Confluence Parkway— Review of City Noise Discipline Report

5 July 2022

Key Findings and Observations

FIGURE 1
Proposed Confluence Parkway
Overview Map

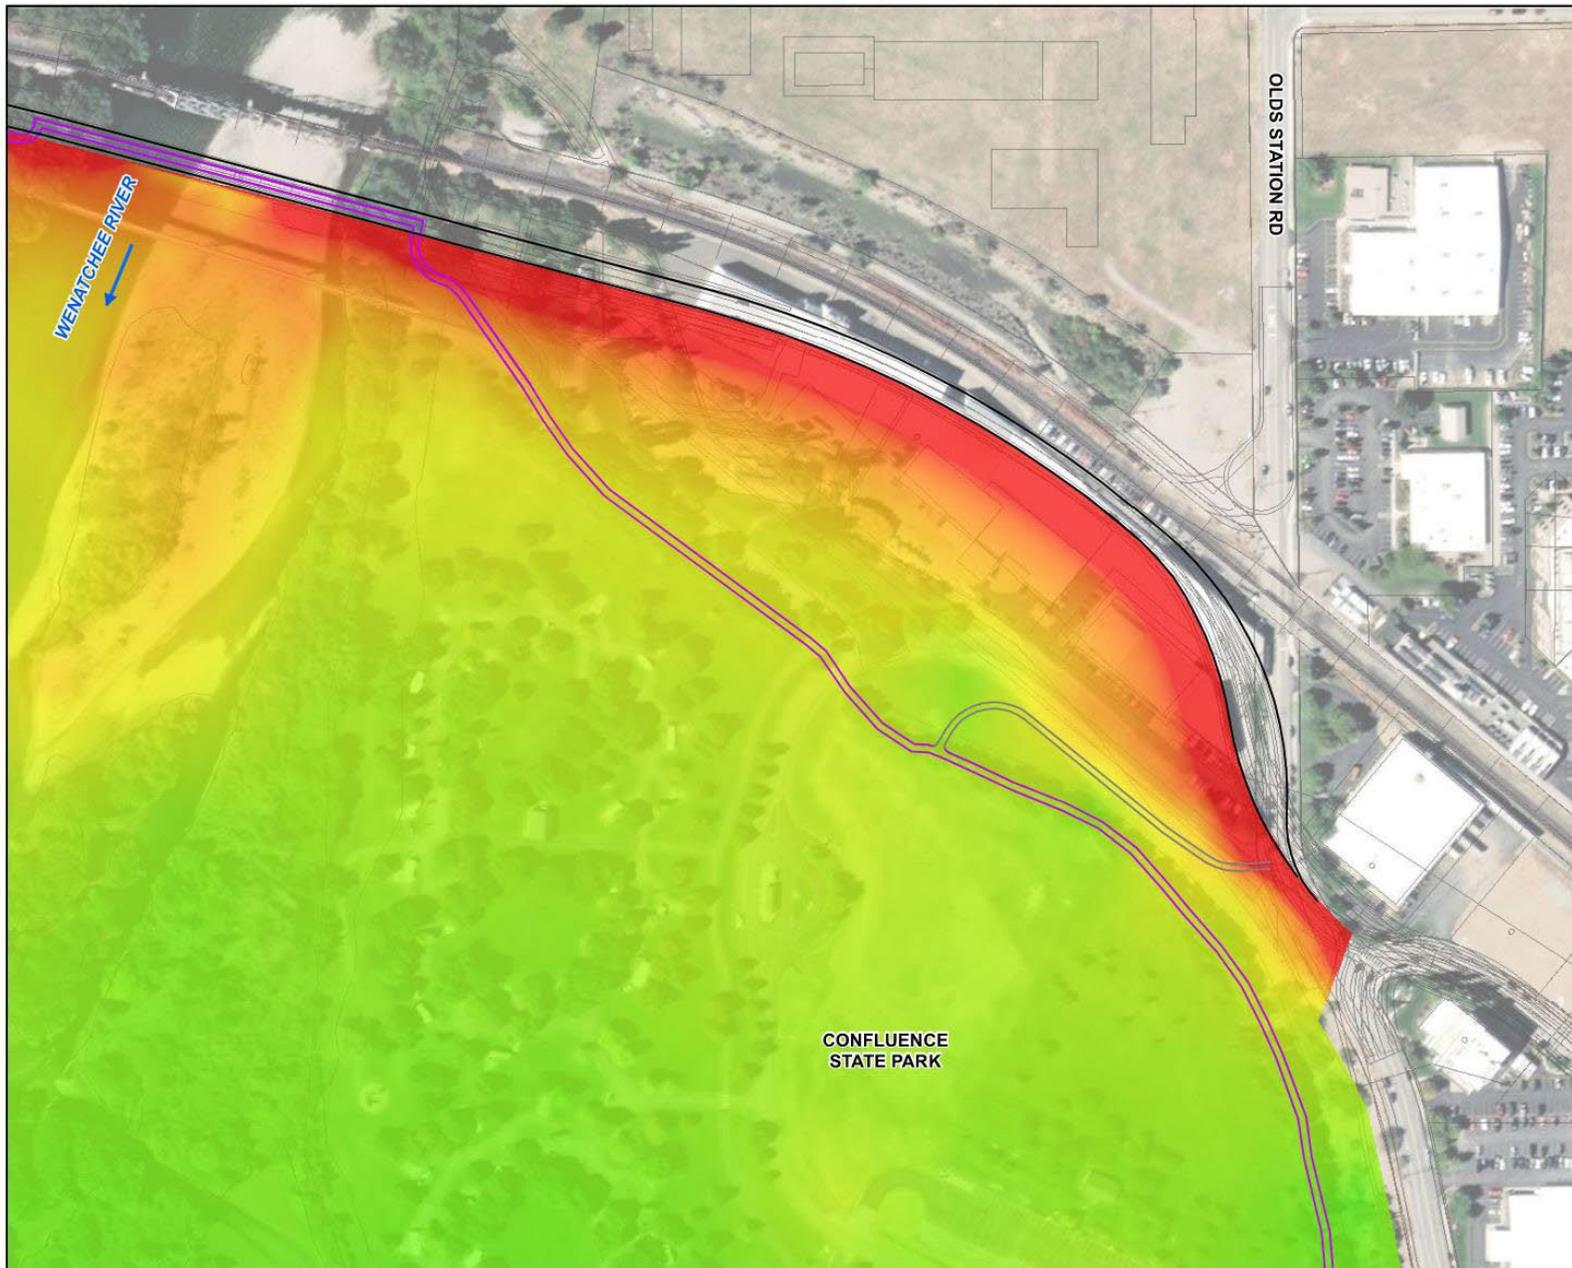
- Less than a 10 decibel increase, i.e. “substantial impact.”
- Less than 66 decibel threshold to be considered an impact.

- Six receptors had a greater than 10 decibel increase.
- Two receptors closest to the “pinch point” experience a 21-23 decibel increase (46 and 47 decibels existing increasing to 67 and 70 decibels future).
- Increase can be reduced to 16-18 decibels with proposed noise abatement (62 and 65 decibels future).
- Existing short-term train noise can be on the order of 60 to 80 decibels, depending on location.

FIGURE 2
Proposed Confluence Parkway
 Noise Contour Map (Abatement Option 1)

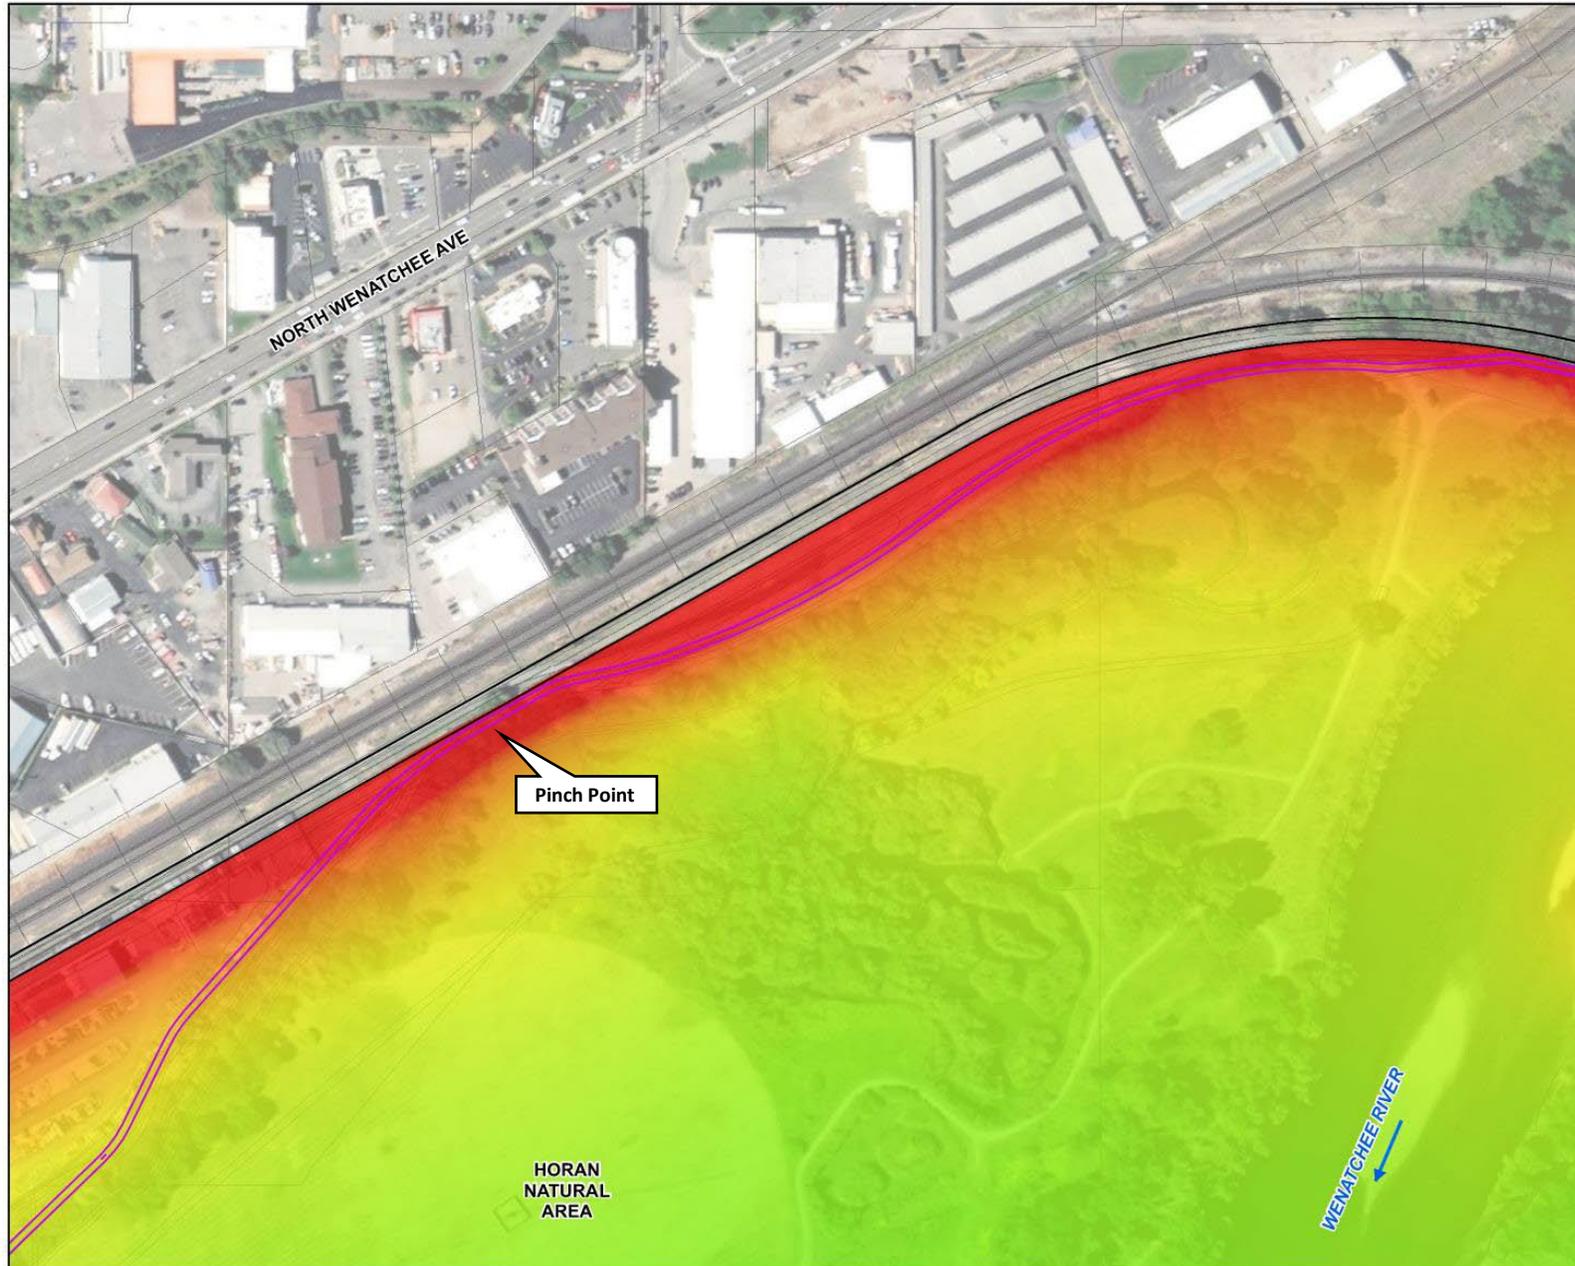
- Option 1 is proposed because it also provides aesthetic enhancement:
 - Three sections of four-foot high earthen berm with landscaping.
 - Four-foot high wall at the “pinch point” for noise reduction.
- City proposes to lower Trail at pinch point by four feet for an eight-foot vertical separation total.
